# TECHNICAL SERVICE BULLETIN

REF.: BRAKES  
NO.: BR95-003  
DATE: AUGUST 18, 1995  
MODEL: ALL MODELS

## INTRODUCTION OF BRAKE SHIM KITS & BRAKE FITTING KITS

#### NEW PARTS:

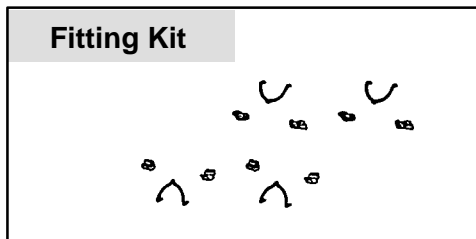
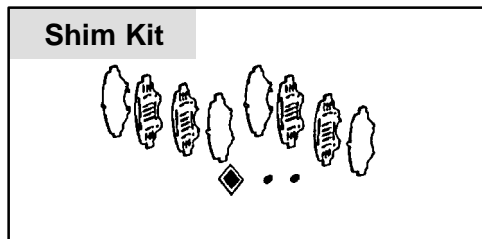
Full brake kits, with complete hardware, have been discontinued. Shim kits and fitting kits for the front and rear brakes are now available separately, along with previously released pad kits.

For the part numbers of these shim and fitting kits, please consult the most recent Toyota Parts Pricing book.

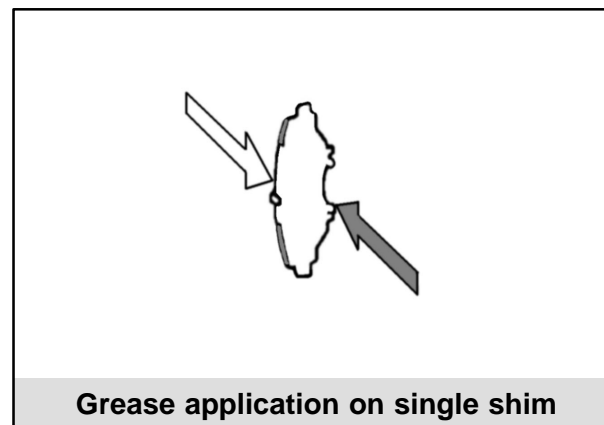
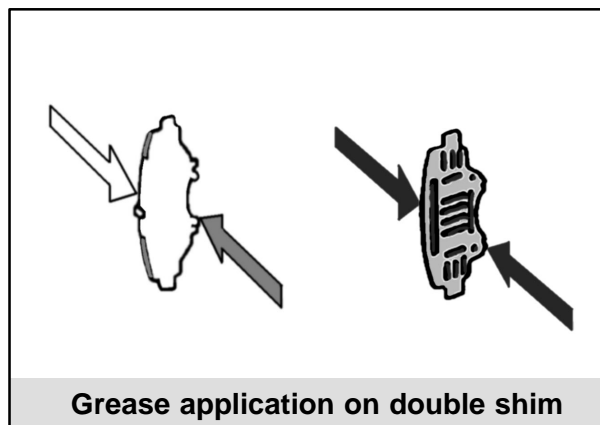
1. All vehicles are to be inspected to insure that the integrity of the complete brake system is maintained. When replacing worn pads, you should replace the shims, wear indicators, (wear indicators may be riveted onto pads for some models) and shim grease at the same time using the pad kits and new shim kit. Vehicles found to need extensive hardware replacement, including anti-squeal springs and support plates, should be repaired using the pad kit, shim kit and fitting kit, which together include all hardware components.
2. When applying shim grease, apply a thin layer over the shim faces as indicated below.

→ = Apply shim grease on this face.

⇨ = Do not apply shim grease on this face (piston side).
